**PALM BEACH COUNTY
PLANNING, ZONING AND BUILDING DEPARTMENT
ZONING DIVISION**

Application No.:	DOA-2010-02574
Control No.:	2004-00457
Applicant:	Principal Development Group, LLC
Owners:	Principal Development Group, LLC
Agent:	CMS Engineering, LLC - Pol Africano
Telephone No.:	(561) 364-3660
Project Manager:	Carol Glasser, Site Planner II

Location: Vicinity of the northwest corner of Hagen Ranch Road and W. Atlantic Avenue (Villaggio Isles MUPD)

TITLE: a Development Order Amendment **REQUEST:** to increase square footage, reconfigure the site plan, modify/delete Conditions of Approval (Architectural Review, Engineering, Landscaping, Planning, Signs, Site Design), and restart the development clock.

Figure 4 Preliminary Site Plan dated December 13, 2010

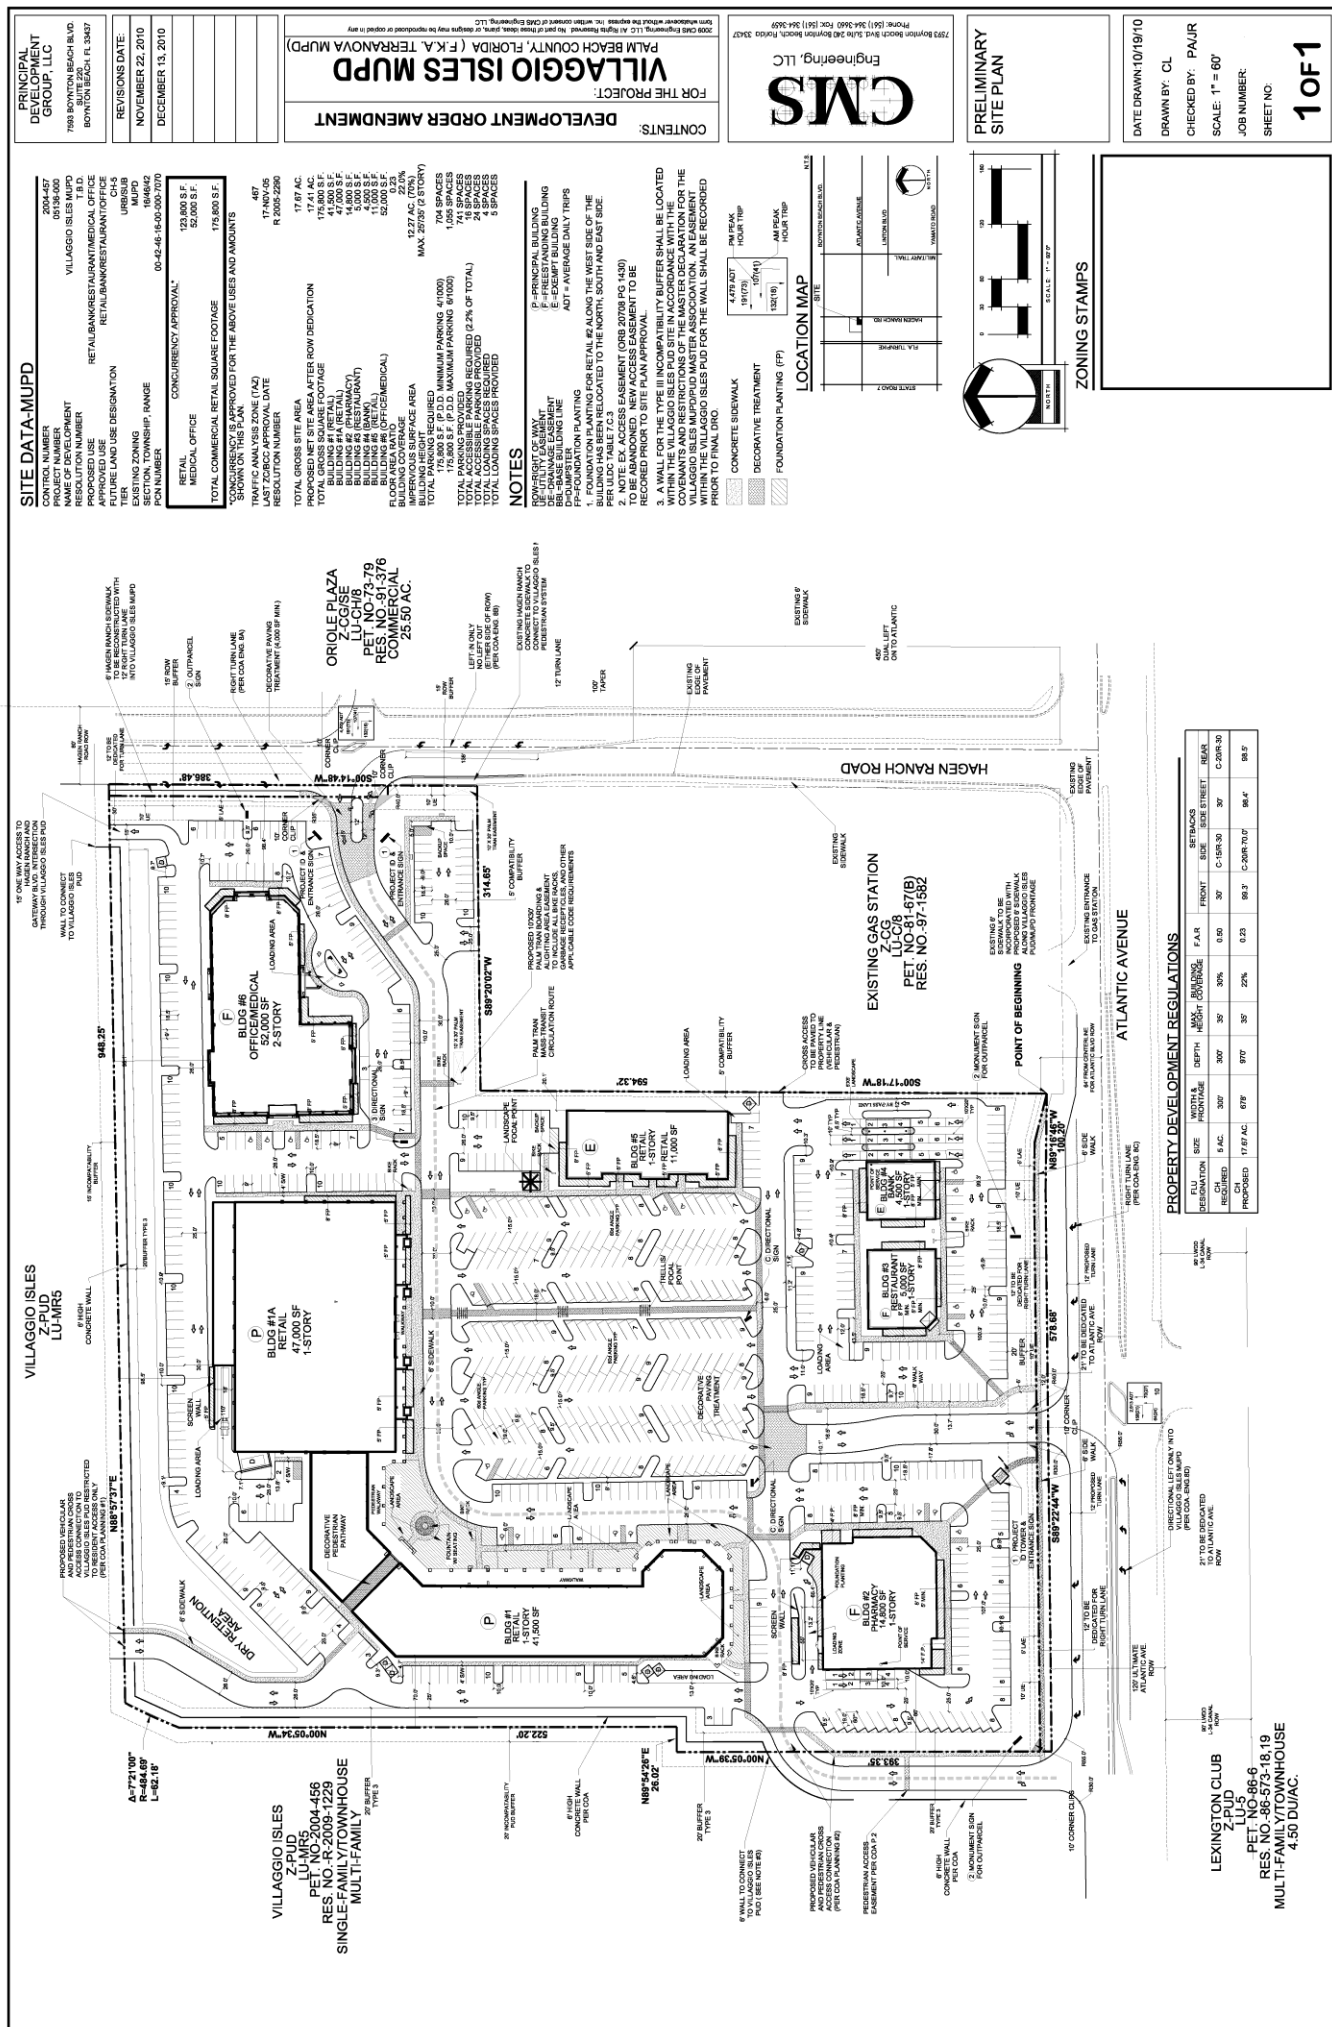
Staff recommends that the conditions of approval be modified/deleted as requested to implement the Preliminary Site Plan dated December 13, 2010. However, the Engineering conditions are marked as "Completed" versus deleted to maintain the monitoring/tracking of conditions of approval. Thus, Engineering 1a-e, 2, 4, 5, and 10 are noted as "COMPLETED per Atlantic Avenue Agreement." Engineering 6 is noted "COMPLETED." The correct build-out date for Engineering 1.f is December 31, 2015. Engineering and the applicant have agreed on amended road drainage easement language for Engineering 9.

north property line. Staff agrees that the proposed redesign of the northern portion of the site to relocate the restaurant (and restaurant's loading area) away from residential and placement of the dry retention area adjacent to the 20-foot wide Type 3 incompatibility buffer mitigates for the request to reduce the width of the buffer. Incompatibility issues are decreased with the proposed medical office use at the northwest corner of the site. Additional setback is also provided for the loading operations and dumpsters serving the primary retail use. A 15-foot wide Type 2 incompatibility buffer with a 6-foot high continuous hedge is provided along the entire length (south and east property lines) of the abutting PUD development.

Staff recommends Site Design 1 and 2 be deleted as requested to implement the proposed Preliminary Site Plan. New Site Design conditions are recommended to address relocation of the sidewalk located on the south side of Building 6 and to condition an alternative buffer at the southern portion of the Type 3 incompatibility buffer. Art. 3.E.3.B.2.c allows an alternative buffer pursuant to BCC condition of approval. The wall for the portion south of the western cross access point is proposed to be within the adjacent 15-foot wide incompatibility buffer of the PUD.

1. Prior to final approval by the Development Review Officer (DRO), the site plan shall be revised to relocate the sidewalk on the south side of Building 6 from the north side of the drive aisle to the south side of the drive aisle. (DRO: ZONING - Zoning)

2. Prior to final approval by the Development Review Officer (DRO), a copy of the Final Site Plan for Villaggio Isles PUD shall be submitted indicating a 6-foot high wall within the east 15-foot incompatibility buffer of Pod E to comply with ULDC Art. 3.E.3.B.2. If this wall is not indicated within the Villaggio Isles PUD Final Site Plan, then the Villaggio Isles MUPD Final Site Plan shall be revised to indicate a 6-foot high wall in the west Type 3 incompatibility buffer south of the vehicular and pedestrian cross access. (DRO: ZONING - Zoning)
